PROJECT NAME: Paul Hopkins Park Pedestrian Bridge

SOLICITATION NO: B191052

RE: ADDENDUM #1

1 BRIDGE PLAN VIEW
S4

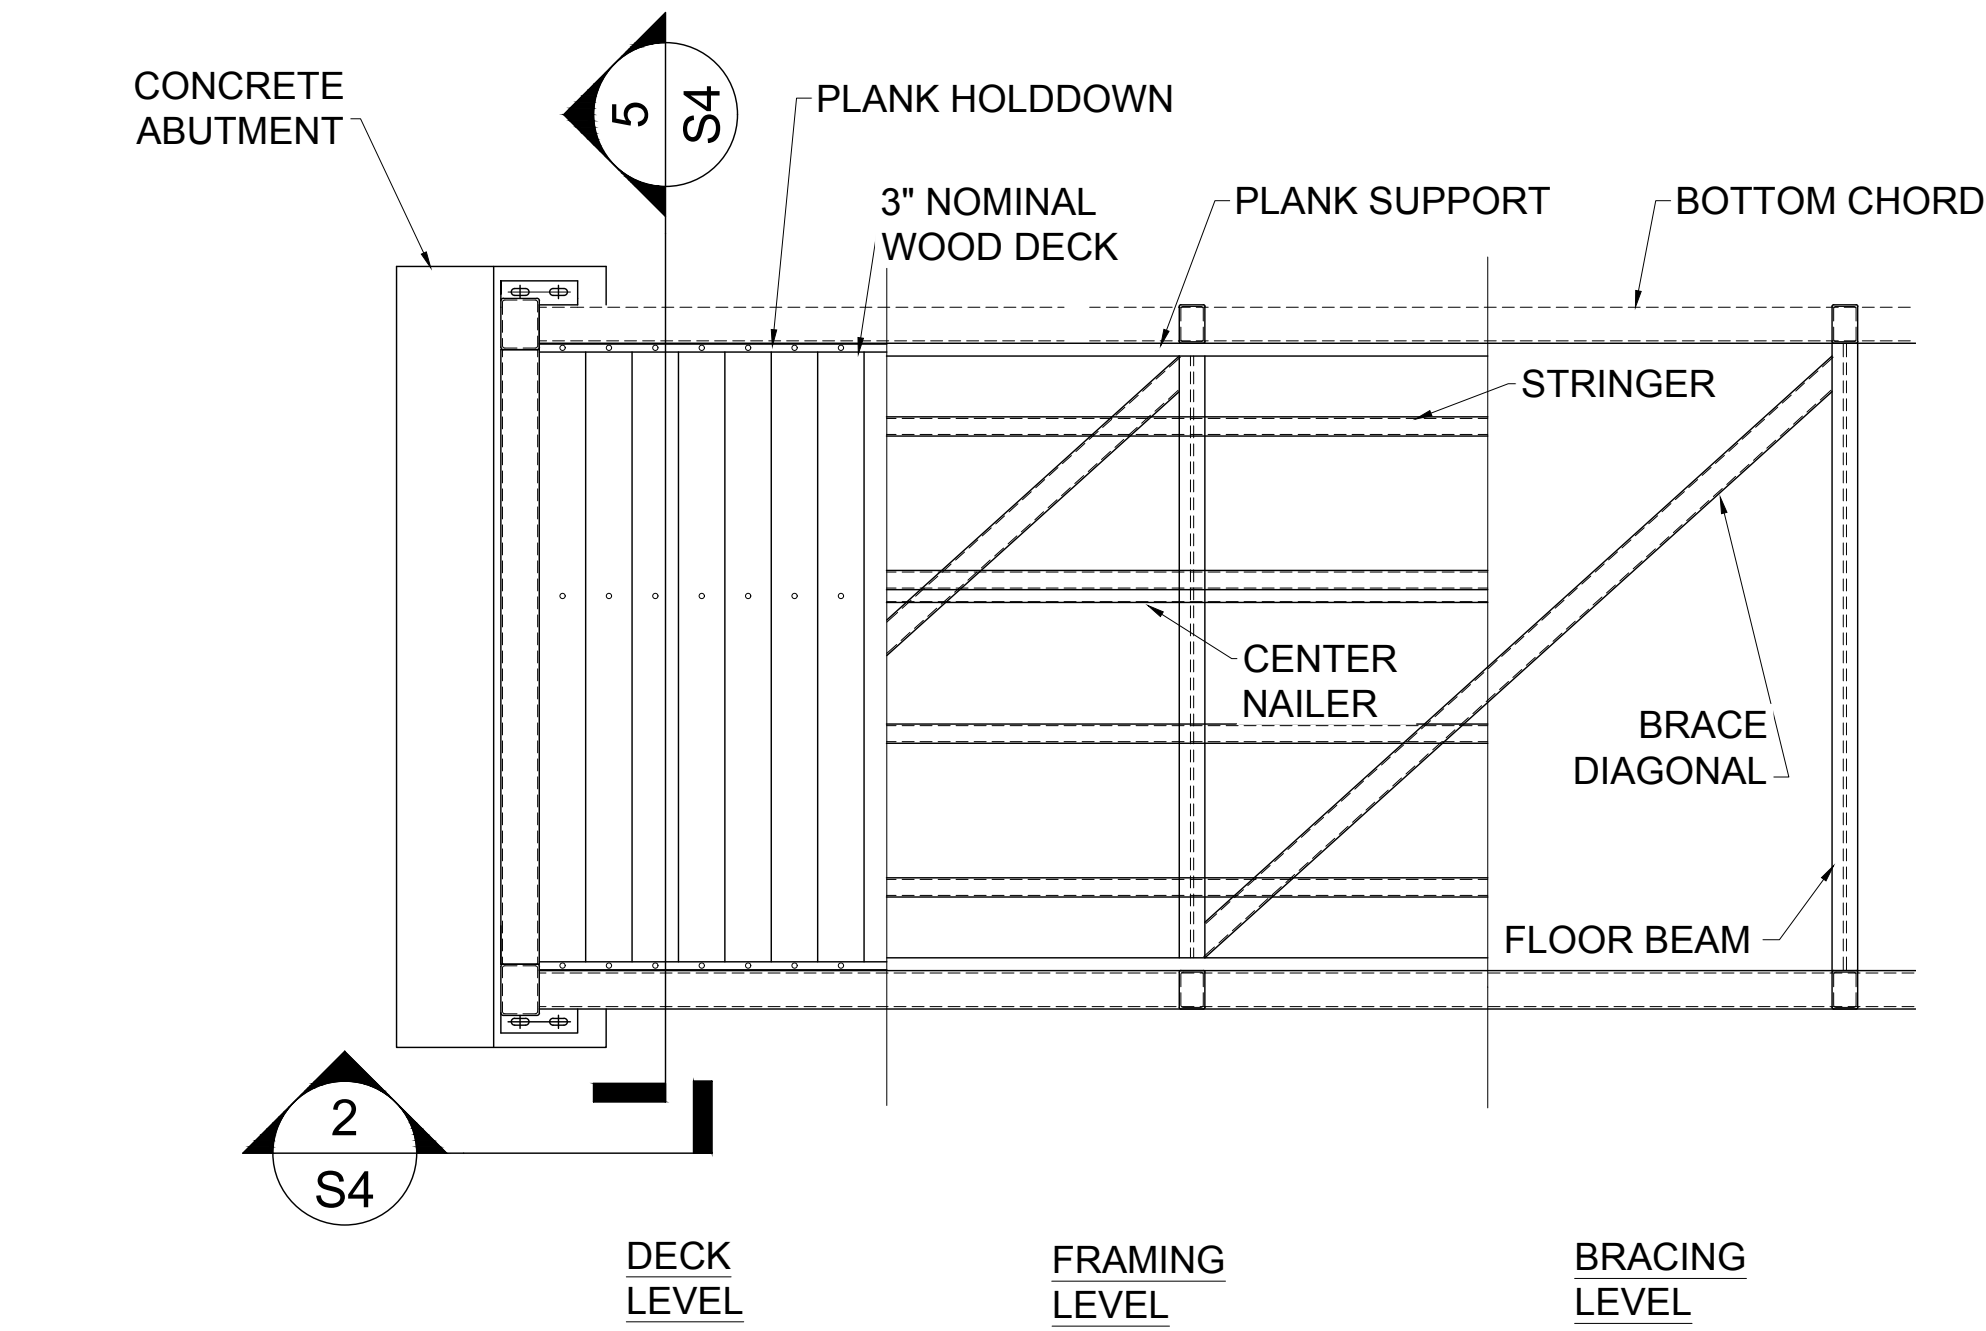
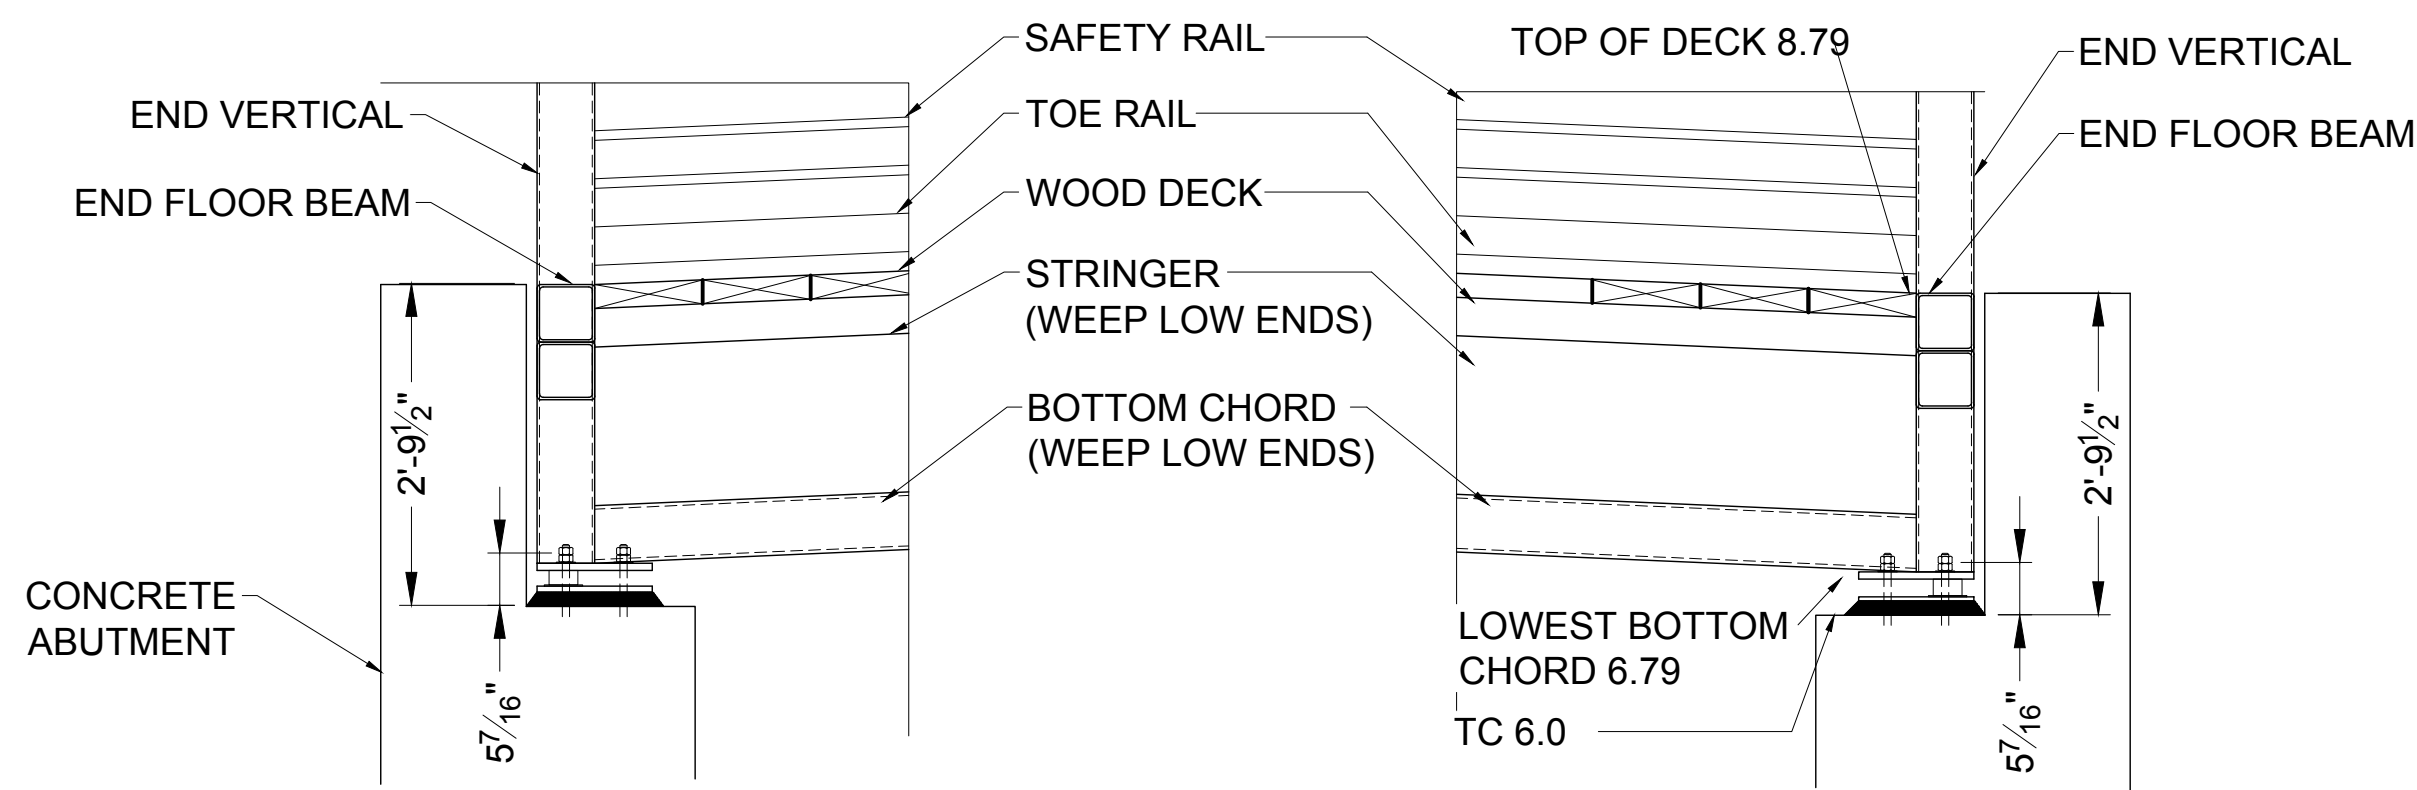
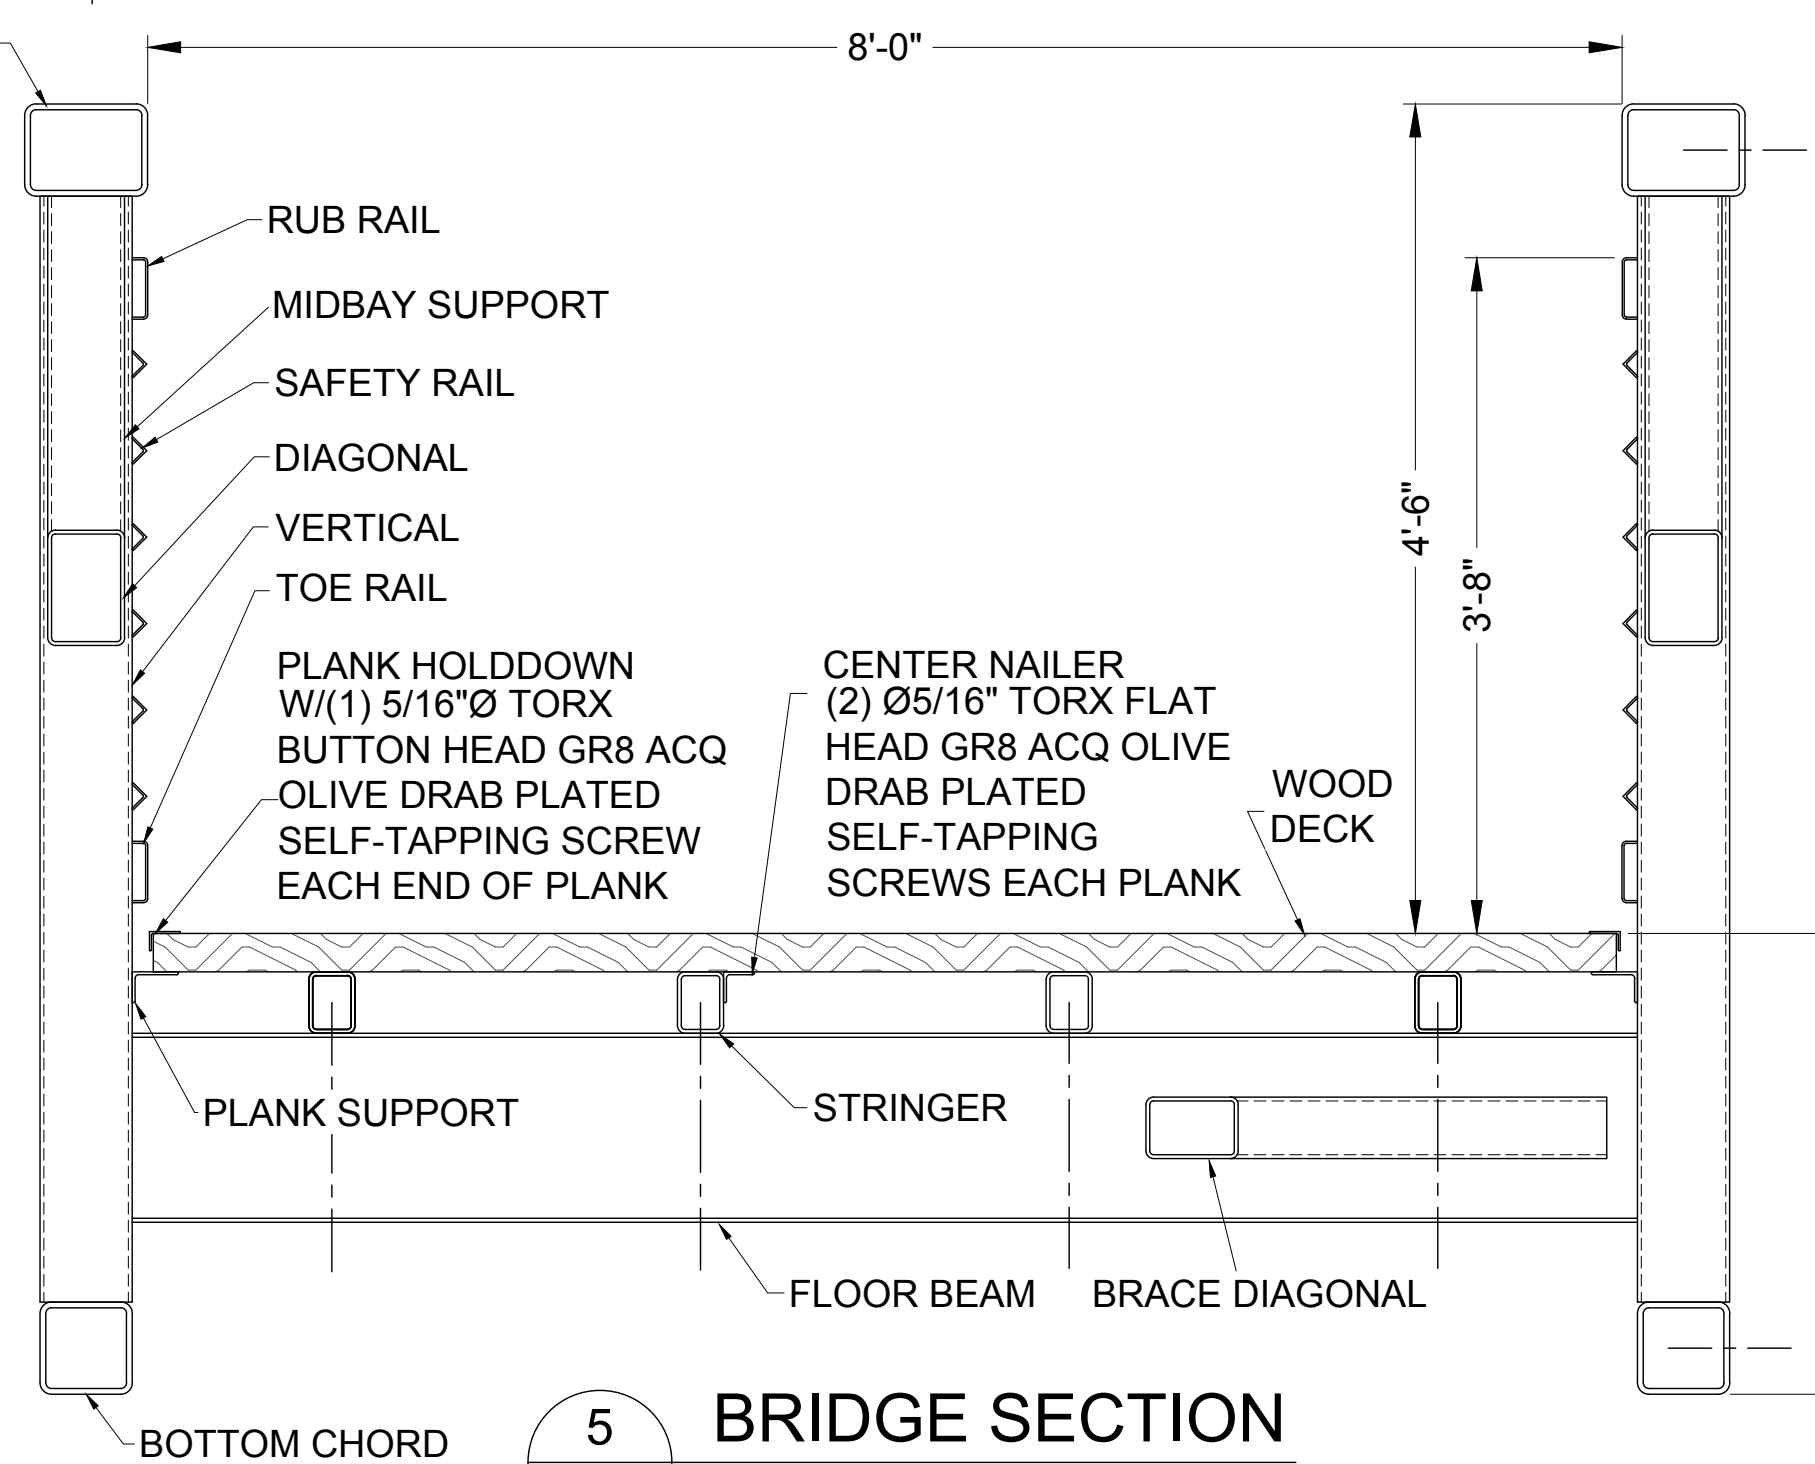
Question #2: Plans show a 90 psf live load. Specs have a 65 psf.

Question #3: Plans show a 10,000 lb vehicles. Specs have a 5,000 lb vehicle.

Question #4: Plans show Horizontal Rails. Specs call out a Vertical Picket system.

Question #5: Plans show an H-section Bridge. Specs call out an Underhung Bridge.

Question #6: Plans call out a 1/2" min. wall. Specs call out a 3/16" wall.

Response: The bridge shall be designed for a live load of 90 psf.

Response: The bridge shall be designed for a 10,000 lb vehicle load.

Response: Horizontal safety rails shall be placed on the inside structure on both sides the bridge up to a minimum height of 42" above the deck surface. Safety rails shall be placed so as to prevent a 4" sphere from passing through the rails. Safety rails shall be 1-1/4" x 1-1/4" x 1/8" angle.

Response: Bridge shall be an H-section Bridge

Response: Minimum wall thickness shall be 1/2".
